STRUCTURAL EVALUATION OF MAGLEV GUIDEWAY CONCEPTS

ABSTRACT: The National Maglev Initiative (NMI) resulted in four distinctly different concepts. The structural systems of the concepts varied greatly, but in general were very complex. This paper evaluates the concepts as to their performance of selected criteria: constructability, reliability, maintainability, adaptability, and durability. Three of the systems used precast, prestressed concrete for the main load-carrying element. One system used aluminum. Only one system, system concept design (SCD-1) could be readily produced in existing precasting plants. None of the systems provided for easy adjustment of operating elements after construction. These systems require construction tolerances that are much more restrictive than conventional practice. Among the stated goals of the NMI concepts were: (1) it should anticipate upgrade; (2) it should be economically and financially attractive; and (3) it should be robust in terms of its susceptibility to adverse weather and its requirement for maintenance. This paper concludes that none of the four concepts adequately met these goals. However, some concepts could achieve the desired goal

FIG. 1. Concept SCD-1—Typical Cross Section

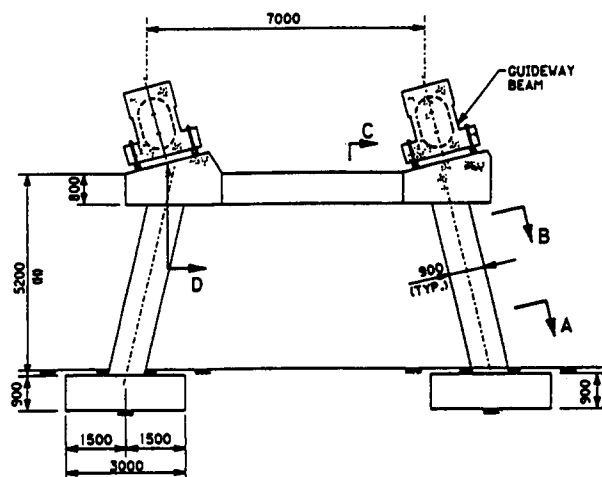
The proposed guideway shown in Fig. 1 is a precast, prestressed concrete box girder to which the levitation, propelling, and guidance systems are attached. It functions basically as a monorail. The typical span is 25 m (82 ft). The substructure is reinforced concrete supported on spread footings.

The apparent design philosophy is to incorporate the direct load-carrying element into the main structural element. This produces a compact section for typical spans, but does not address the need for longer spans over major streams. Use of standard bridge elements was not considered. Need for adjustment in the field was not sufficiently addressed. Details of the structural element of the guideway are shown in Fig. 2. Details of the magnet attachment are shown in Fig. 3.

For reliability this concept appears to meet the criteria. However, the relatively long span, 25 m (82 ft), of the basic guideway raises questions about the amount of differential deflections due to creep of the prestressed concrete. Also, the

FIG. 2. Concept SCD-1, Detail of Structural Element: (a) Elevation; (b) Section B-B; (c) Section A-A

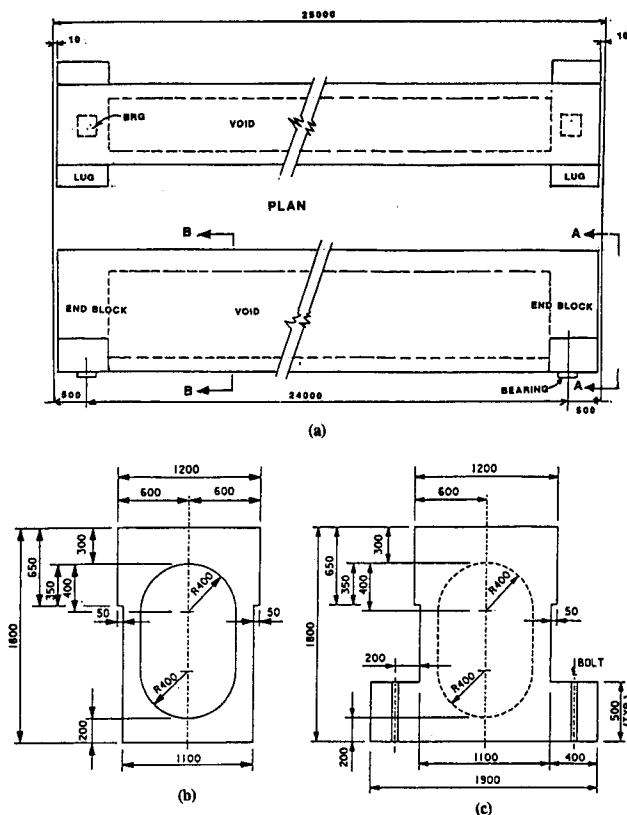
For constructability this concept has merit. The guideway of prestressed concrete could be produced by existing precasting plants. The substructure is a common type. However, there are serious concerns about the use of concrete end lugs cast integral with the guideway and the use of end blocks. These items greatly complicate the fabrication. If these deficiencies are corrected and if the length of the element is limited to the typical span (25 m), then the concept meets the criteria.

FIG. 3. Concept SCD-1—Attachment Detail, Driving Element

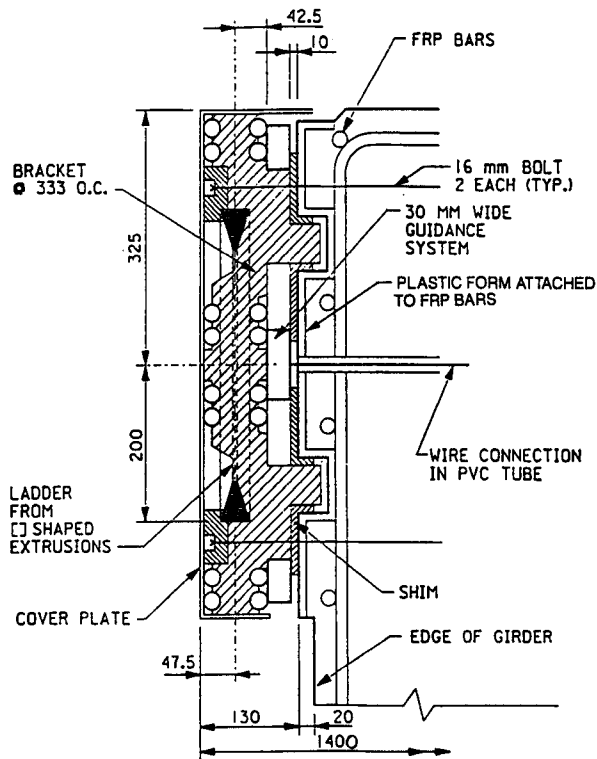
For maintainability this concept needs significant modifications. The attachment of the driving and guidance elements to a plastic form (Fig. 3) cast in the guideway allows very little adjustment. In addition, this adjustment is inaccessible and would require unmounting of the elements. The long length of the straight guideway, 25 m (82 ft), requires a horizontal offset of 13 mm (0.5 in.) on a 3,200 m (2 mi) radius curve. This is additive to the other construction tolerances that require adjustment.

FIG. 4. Concept SCD-2—Typical Detail of Structural Element

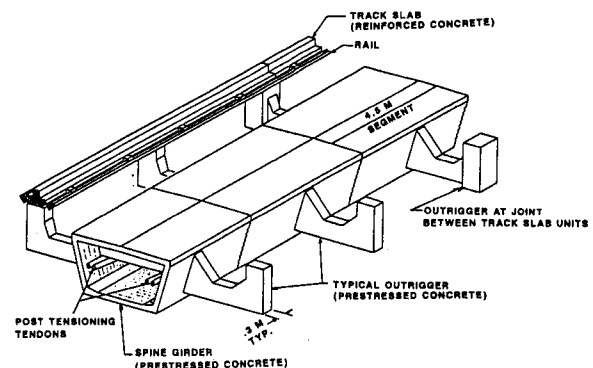
For constructability this concept has many points of difficulty. The design of the guideway requires segmental construction of an unusual shape. The basic concrete box girder segment has an interior diaphragm and exterior cantilevers. The length of each segment is 4.5 m; the overall width is 4 m; and the height is 1.8 m. The main reinforcement of the cantilevers is a draped posttensioning strand. These segments would be

Overall this concept, at the present stage of development, needs significant modifications. However, if the track slab were supported on an independent structure, built of commonly used elements, it could be workable.

FIG. 5. Concept SCD-2, Post-Tensioning Details: (a) Section A during Initial Installation; (b) Section B during Initial Installation; (c) Section A during Tendon Restressing; (d) Section B during Tendon Restressing

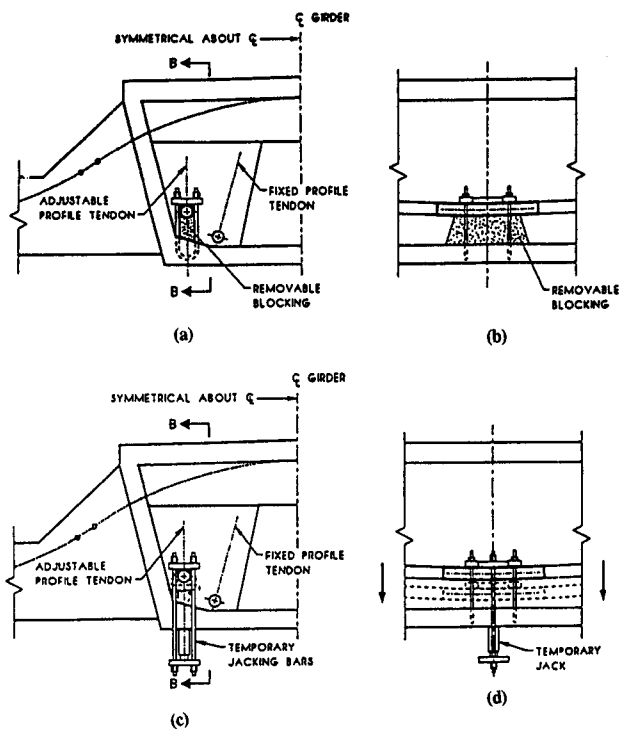
difficult to fabricate and to transport. The posttensioning elements of the box girder are external strands located inside the box girder. A special device shown in Fig. 5 is provided to permit restressing of the tendons. This increases the field labor. In summary, this concept uses minimum material, but is very labor intensive both shop and field.

FIG. 6. Concept SCD-2—Track Slab Details

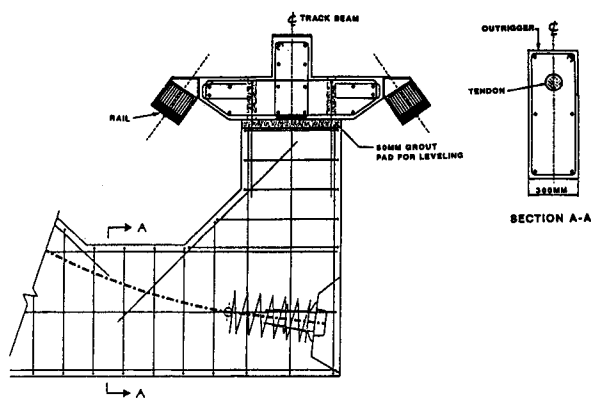
Depending on the operational tolerances of the vehicle suspension system, these deflections could produce a less than desirable ride. A detail of the track slab that is supported on the cantilevers is shown in Fig. 6. The entire load of the vehicle is transferred to the track slab by steel brackets spaced 2.25 m apart. Details of these brackets were not clearly shown, but they represent critical connections. They function in shear and tension and must be attached to the edge of the track slab, which is only 120 mm deep.

cations. The only adjustment, other than that provided by restressing the main posttensioning strands, is a 50-mm grout pad provided on the top of the cantilever post shown in Fig. 6. Once the track beam has been adjusted to the right position, this grout is placed and set. After that adjustments would require demolition. Provisions for adjustment of individual track beams were not shown.

FIG. 7. Concept SCD-3—Typical Cross Section

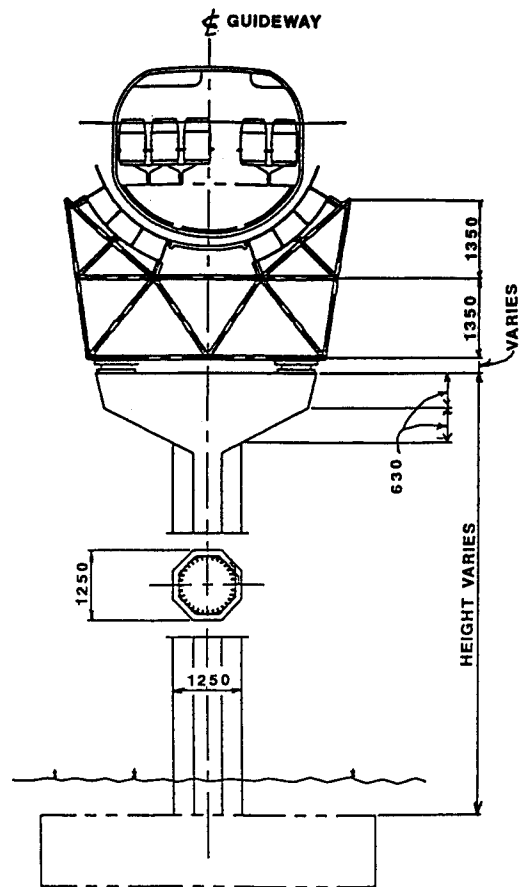
For constructability this concept needs an in-depth study. Welded aluminum sections require highly specialized fabrication techniques. Fabrication of curved box beams from thin plates is very difficult. Providing adequate support for the box beams is field labor intensive. Tolerances would be difficult to meet.

For reliability this concept also needs further study. During operation, the levitation plate could experience a 180°C (325° F) rise in temperature due to the frequent passage of vehicles. Since the levitation plate is an integral part of the curved box beam, there will be serious temperature strains that could cause deformations and large stresses in the guideway. The proposed expansion joint shown in Fig. 8 relies on the bearing of the levitation plate on a backing plate. This detail has no provision for these deformations.

FIG. 8. Concept SCD-3—Expansion Joint Detail

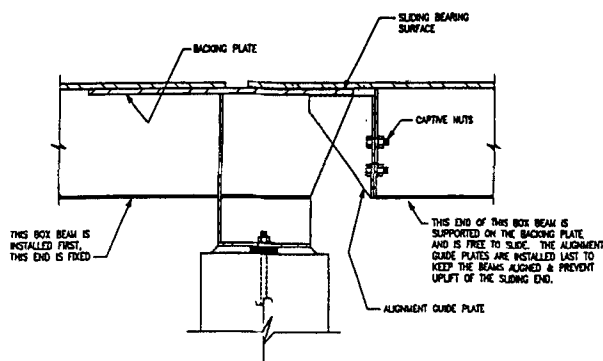
For maintainability this concept would be difficult. The interior of the box beam is inaccessible for inspection and maintenance. Also as shown in Fig. 8 there will be uneven and highly concentrated wear on the levitation plates due to temperature movement, and hence more maintenance. On the plus side, the large gap between the vehicle and the surface of the

For adaptability this concept is limited. Any future improvements that would require dimensional changes in the vehicle or guideway could be extremely difficult to install. The ability to replace a faulty guideway element with another element is restricted. This is particularly true at the proposed expansion joint.

For durability this concept is uncertain. The extensive use of aluminum, particularly in curved thin plates, has a potential of becoming deformed due to high temperatures and secondary stresses. The wear at the expansion joint could severely limit the life of an element. Aluminum has a low fatigue threshold and therefore must be designed for a very low service load stress to achieve a reasonable service life.

FIG. 9. Concept SCD-4—Typical Cross Section

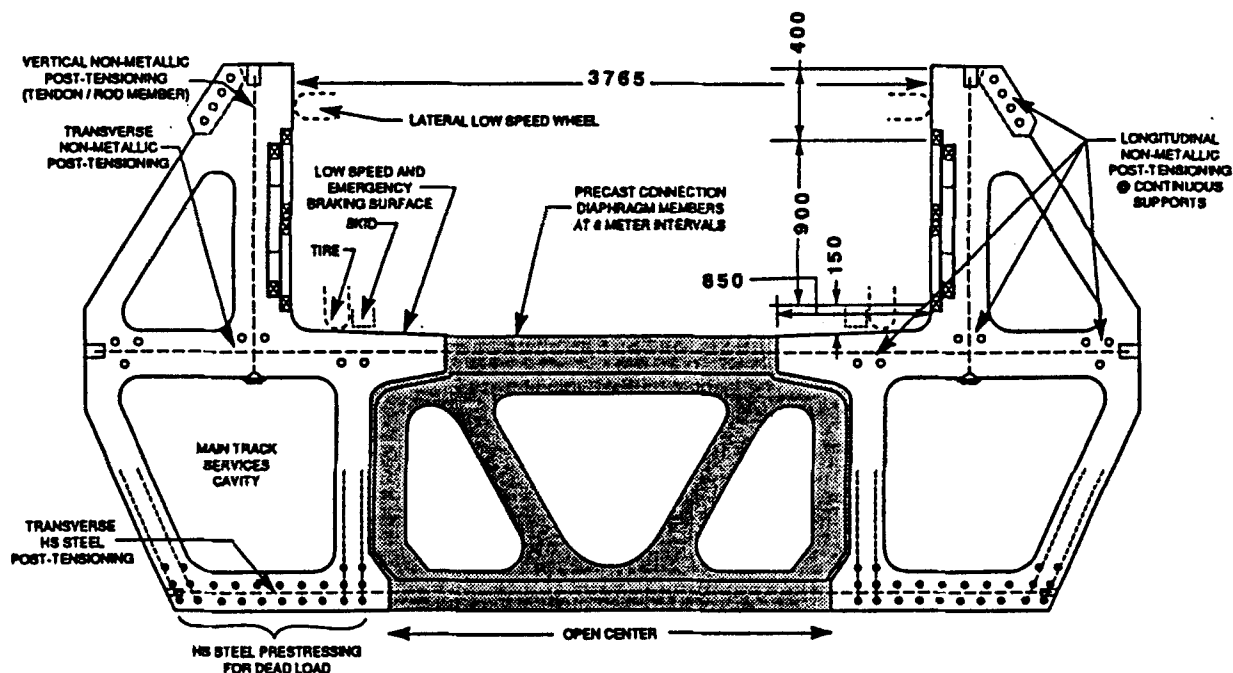
For constructability this concept needs significant modifications. The unusual, nonsymmetrical shape of the guideway elements is very difficult to form and cast. The odd shaped diaphragms spaced 6 m apart makes erection very difficult. The guideway elements cannot be placed in position before installing the diaphragms. There are 432 transverse and vertical glass fiber, reinforced plastic posttensioned (GFRP) bars for every 27-m span. This is very field labor intensive.

tions. There are many weak points in this very complex structure that could develop flaws. This is particularly true of the many GFRP strands. Repair of this weak point is very difficult.

For maintainability this concept needs further study and development. There are no provisions for adjustment of the elements of the guideway. Details of end diaphragms for bearings were not shown. However, access to the voids for inspection would be very difficult. There is a need to periodically check the GFRP posttensioned strands to ensure adequacy of stress.

For durability this concept needs an in-depth study. The extensive use of GFRP is a concern. Its long time performance is not proven. The complex shapes are certain to induce secondary stresses, which may be detrimental.

Overall this concept, at the present state of development, raises many questions. However, if the structural elements to which the levitation, propulsion, and guidance systems are attached were separated from the main carrying member the concept could be a workable one.
